Sub: Joint Meeting of the Standing Committee on Power System Planning of
Southern Region and Western Region - Minutes of the meeting

Minutes for Joint Meeting of Standing Committee on Power System Planning in Southern Region and Western Region **held on 20 April, 2015 at NRPC, Katwaria Saria, New Delhi**

2.0 Modification proposed by PGCIL in Raigarh-Pugalur- Kerala 6000 MW HVDC System

SYSTEM STUDIES : Southern Region 2018-19

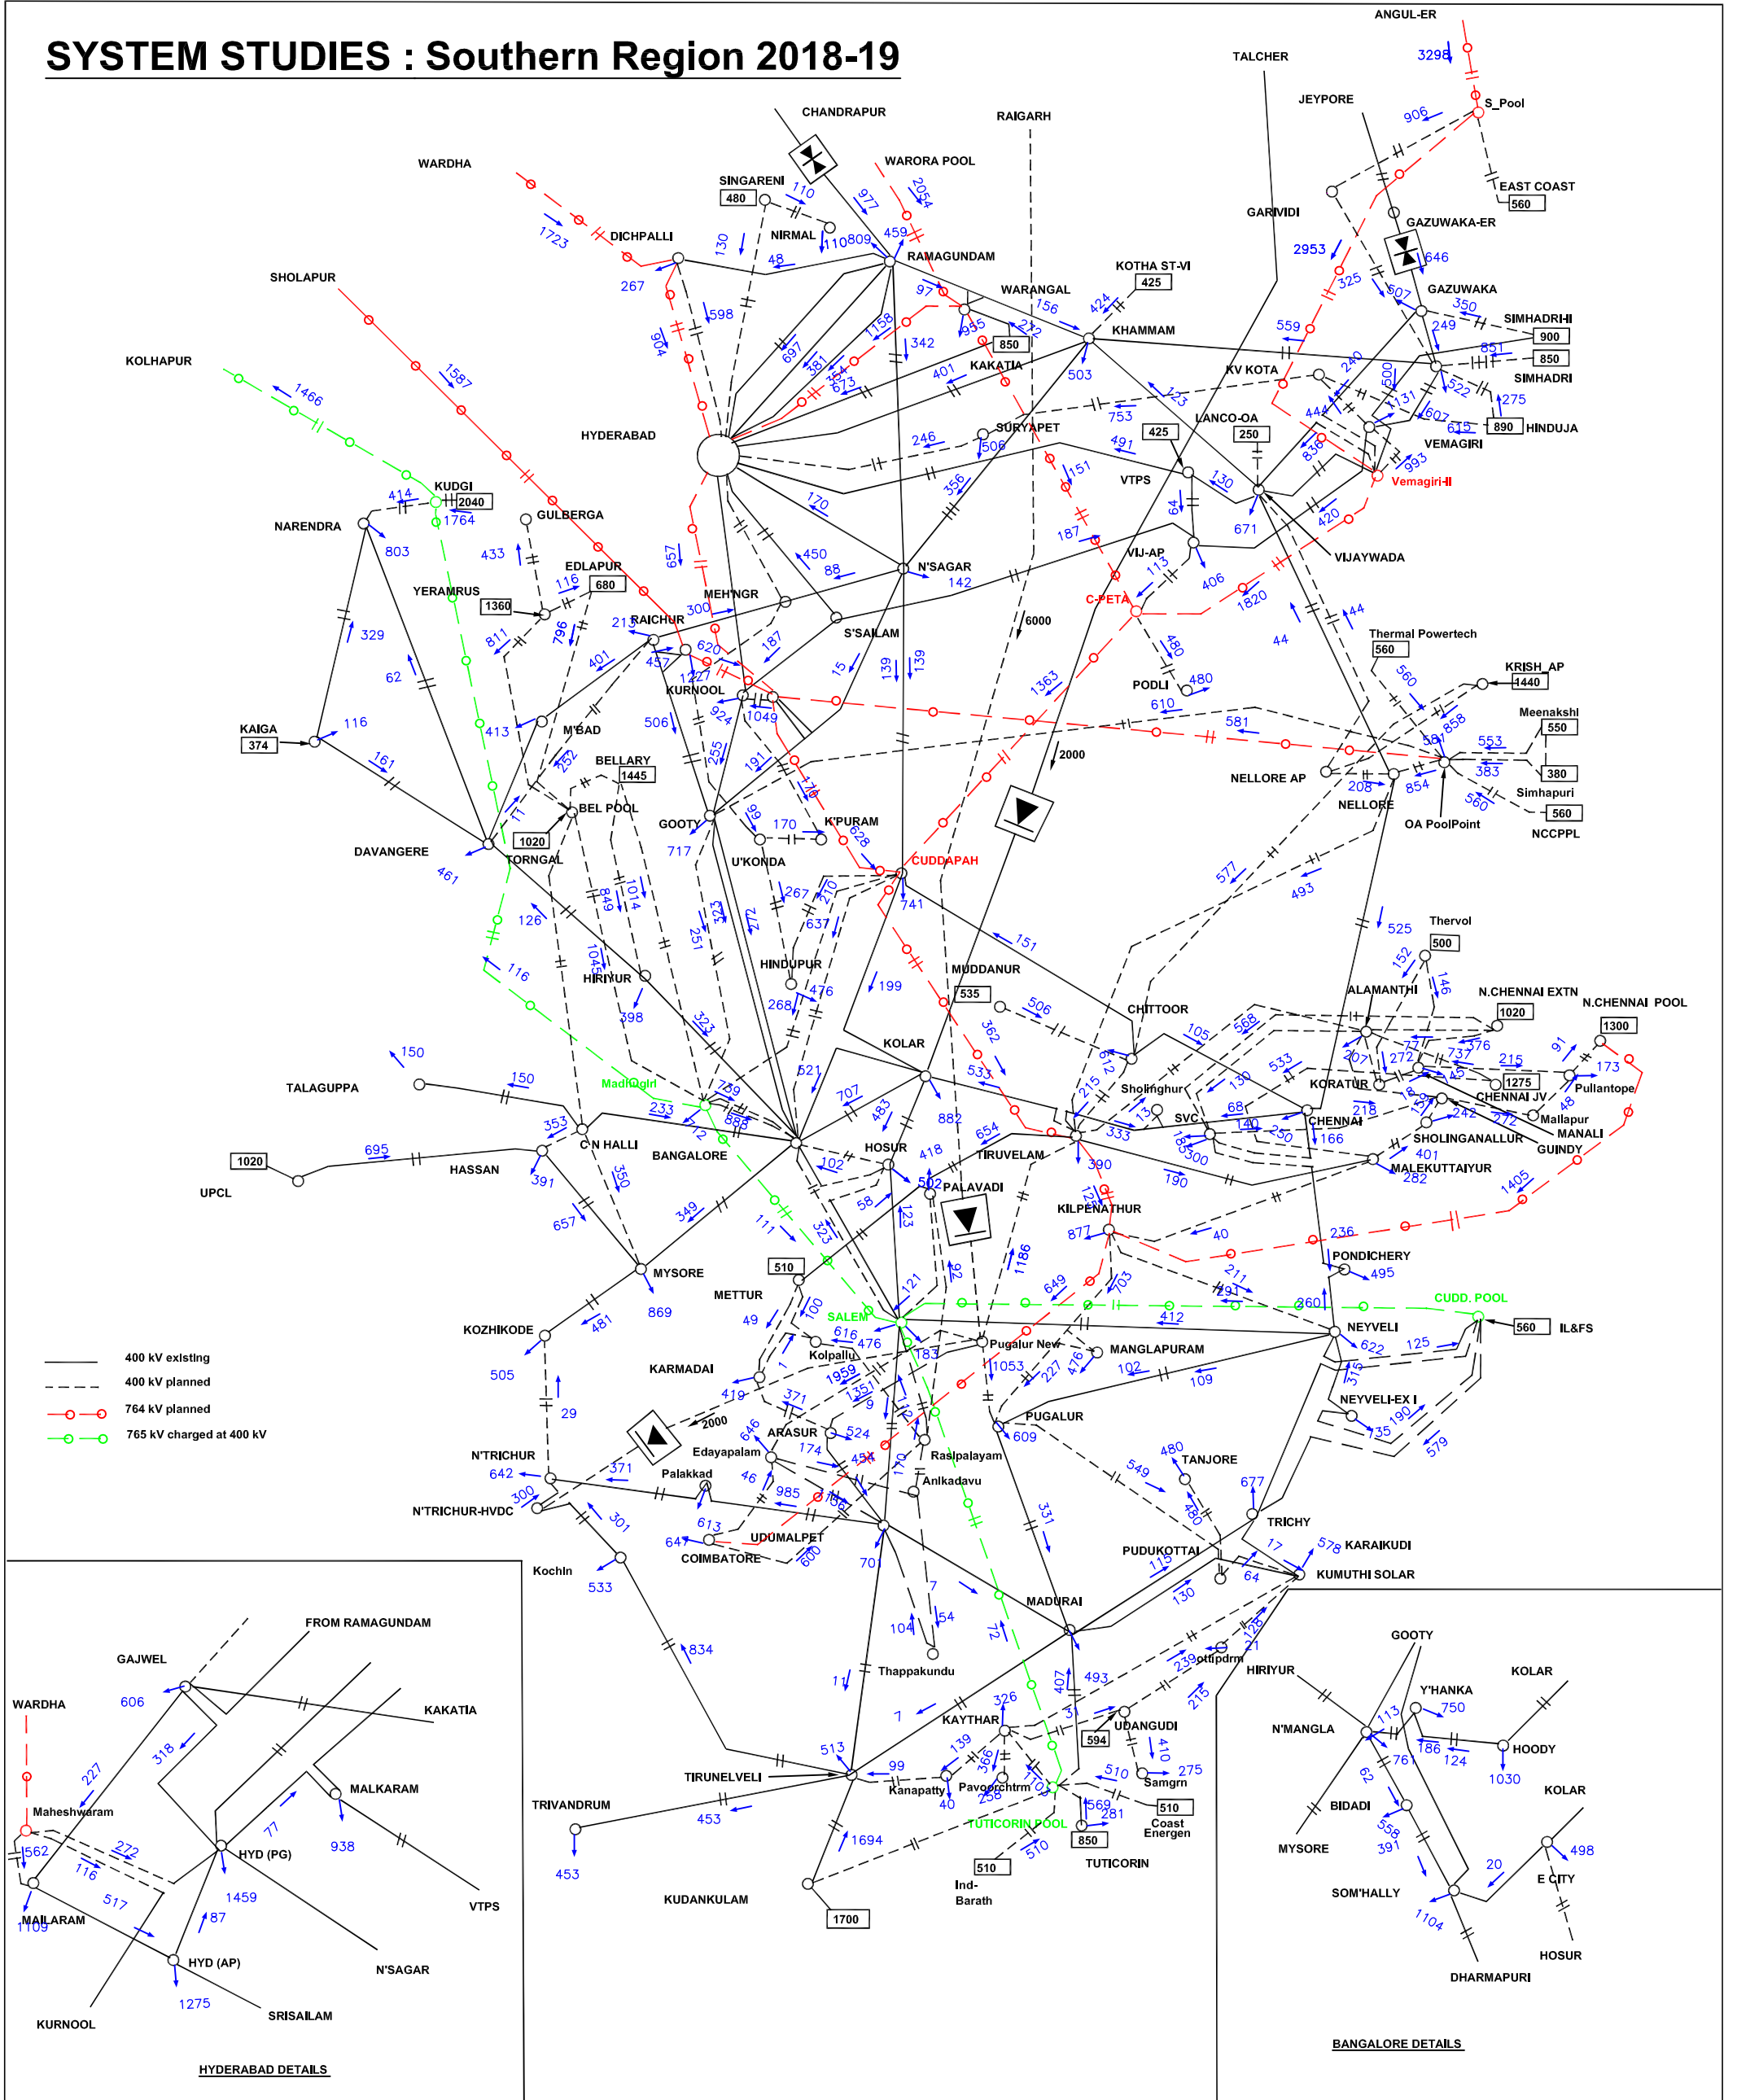
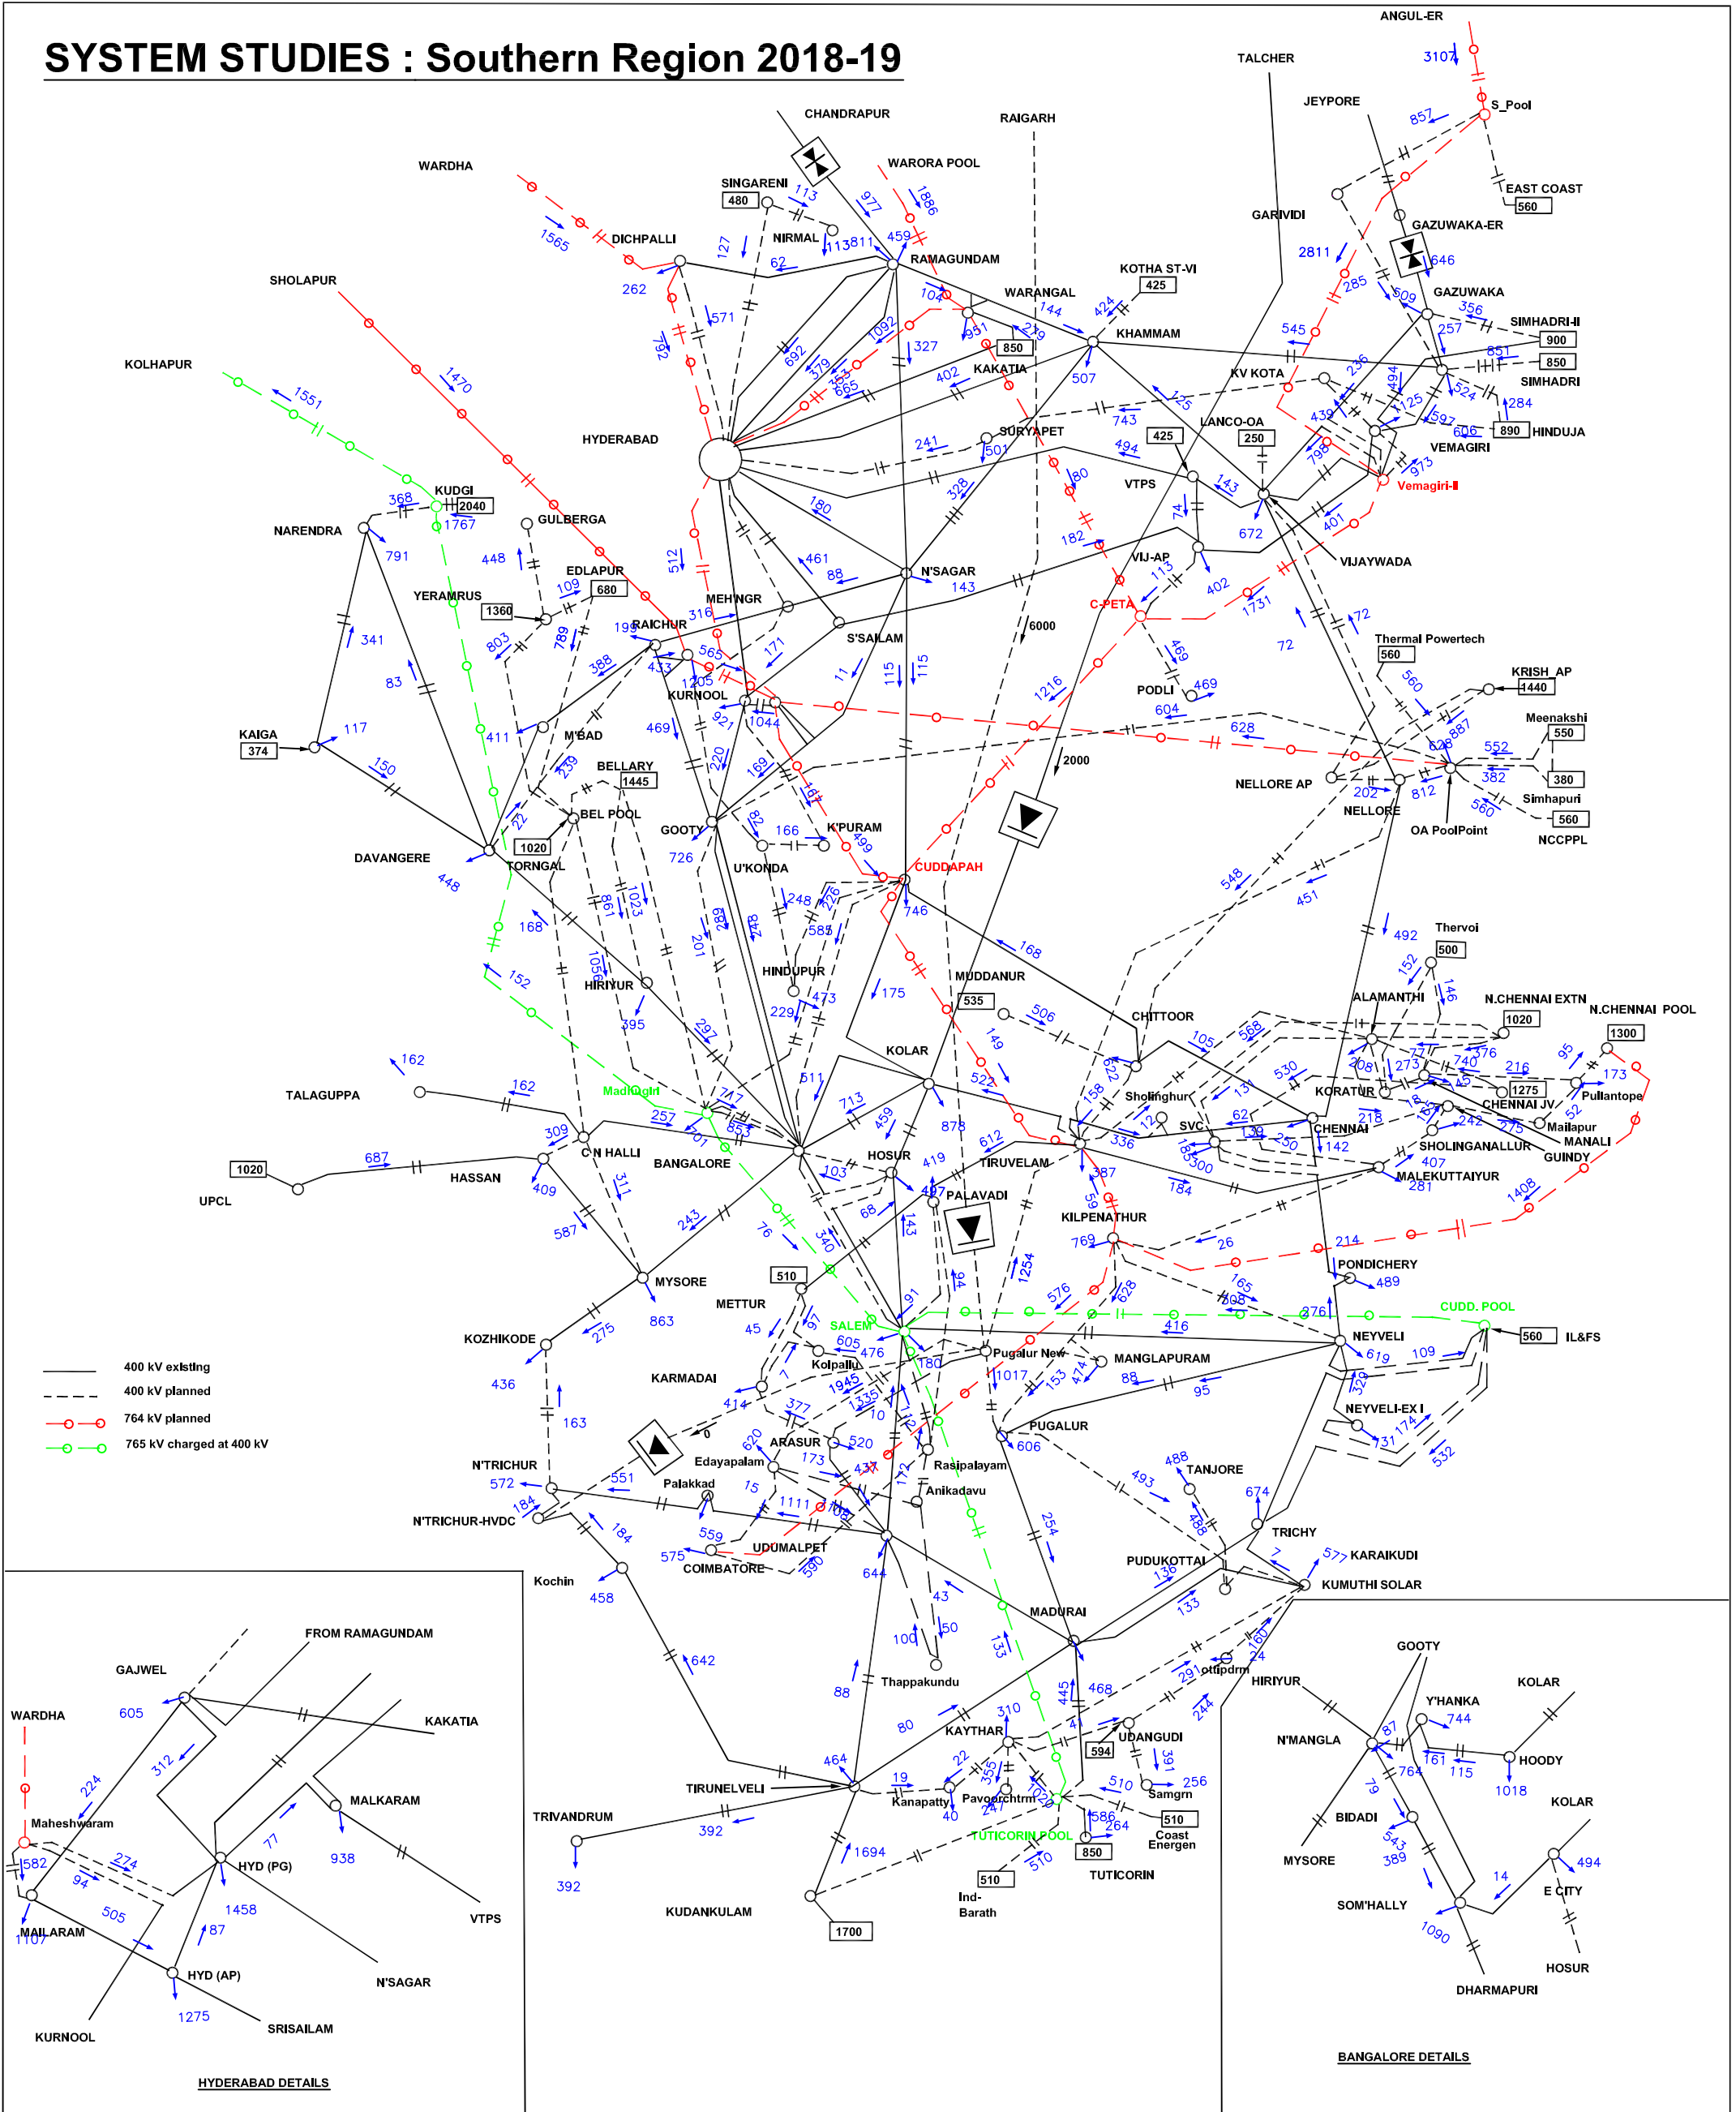
- n. **System Studies for** inter connection of North Trichur HVDC Station with 400kV system in Kerala. Indicative transmission system strengthening required in Kerala state network, so that 2000 MW gets absorbed in the Kerala without overloading/congestion of the 220kV or 110kV network in Kerala. It is requested that corresponding loadflow and SLD file may also be sent to CEA.

(n):System Studies for inter connection of North Trichur HVDC Station with 400kV system in Kerala. Indicative transmission system strengthening required in Kerala state network, so that 2000 MW gets absorbed in the Kerala without overloading/congestion of the 220kV or 110kV network in Kerala. It is requested that corresponding load flow and SLD file may also be sent to CEA.

Reply- Studies has been carried out with 2000MW injection at North Trichur. Injection is through LILO of Cochin-North Trichur 400kV D/c (Quad line). The total load of Kerala is about 5425MW which is met by self-generation of 1360MW and import of 4065MW. The details of tie line flows are shown in Exhibit-I. From the Exhibit-I it is seen that Edamon-Tirunellveli is loaded to 363MW per circuit. Under one pole outage the loading on the line increases to 376MW on each circuit. For above load-generation balance in the absence of proposed HVDC bipole, loading on Edamon-Tirunellveli is 390MW per circuit.

Load flow simulations are plotted in **Exhibit-II & III**. Under (n-1) condition, no constraint is envisaged on line loadings around North Trichur. However, transformers at Cochin and North Trichur gets loaded to 694MW (630MW) and 780MW (630MVA) even under base case. Transformers augmentation as proposed during 37th SCM needs to be taken up with matching 220kV augmentation. Under (n-1-1) contingency if both North Trichur-North Trichur (HVDC) are taken under outage then the entire power would flow towards Kochin and about 1285MW is dropped through transformers and remaining power flows towards Tirunelveli. Strengthening of 220kV to be taken up at Kochin.

In case-1 the 220kV network around Kochin area gets highly over loaded. For Exhibit-2b power flow on HVDC is restricted to 600 MW and load of Kerala to 3850MW to bring the transformer loading on Cochin within the limits (610MW).

Present Proposal (Alternative-II)

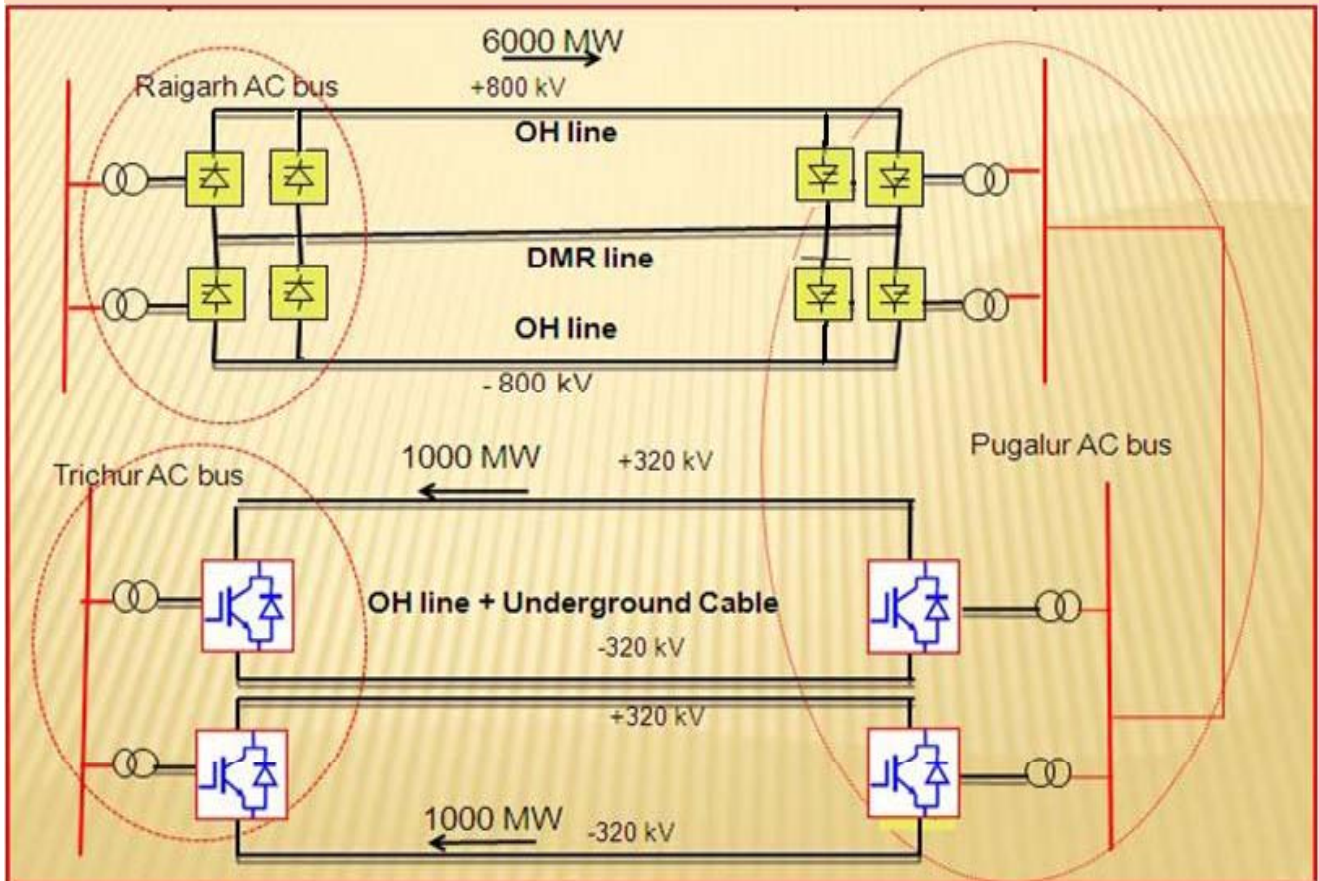
- (i) The new proposal consists of additional + 320 kV, 2000 MW inverter/ Converter terminals at Pugalur and North Trichur.
- (ii) The above is in addition to ± 800 KV 6000 MW inverter/ Converter terminals at Raigarh and Pugalur. Thus total 8000 MW terminal sets are proposed instead of 6000 MW.
- (iii) The additional 2000 MW capacity terminal-set would be VSC based HVDC technology instead of conventional HVDC technology.
- (iv) The reason of this modification in the scope, as given by PGCIL, is uncertainty/ delay in obtaining 69m RoW for the ± 800 kV HVDC line between Pugalur and N Trichur. Therefore, the proposal also contains

- (v) The now suggested modifications would have additional cost impact, primarily, due to following aspects:
 - a. Additional set of 2000 MW terminal
 - b. Use of VSC technology which is costlier than conventional HVDC by about 1.3-1.7 times.

- c. Cost of VSC HVDC cable between Pugalur and N Trichur including cost required to purchase 5 m width of land throughout the stretch.
- (vi) The certainty/ uncertainty in procurement of 5 m wide land in the stretch from North Trichur up to Kerala border to Pugalur, for cable laying also need to be deliberated.

- (vii) Barring cost implications, the use of VSC technology for overhead transmission line is yet to be established/ matured and at present there are only one or two such overhead lines in the world.

- Establishment of \pm 800 kV, 6000 MW HVDC Terminal (4x1500 MW size) at Raigarh and Pugalur (consisting of two bipoles in parallel) with 1.33 pu continuous overload for each 1500 MW converter.)
- \pm 800kV HVDC line between Raigarh and Pugalur.
 - Establishment of \pm 320 kV, 2000 MW (2x 1000 MW size) VSC Terminal at Pugalur & North Trichur.
 - The connection of Pugalur to N.Trichur by +320 kV HVDC line (apprx. route length 220 km, ROW equivalent to 400 kV D/C) and +320 kV HVDC cable (apprx. route length 33 km, ROW 4 m)
- Estimated cost: INR 19742 Cr (approx.)

**Difference in cost Between Alt-II and Alt-I = Rs 485 Cr.
(Incremental cost is less than 5% as compared to Alternative-I)**

- Lesser footprint of the smaller towers used for the +320 kV DC line can address ROW problem
- Lower cost of extruded XLPE cables (3cr/km) can be used with minimal ROW in the route closer to cities and dense habitation where it is difficult to obtain ROW for +320kV overhead line.
- Dynamic voltage support at converter bus at both Pugalur and North Trichur through dynamic compensation.
- Footprint for terminal is less (approx. 50% of LCC of same rating)
- Both LCC (a) and VSC (c) terminals can be controlled separately and can independently offer flexibility.
- Procurement of land may be required along the cable route.
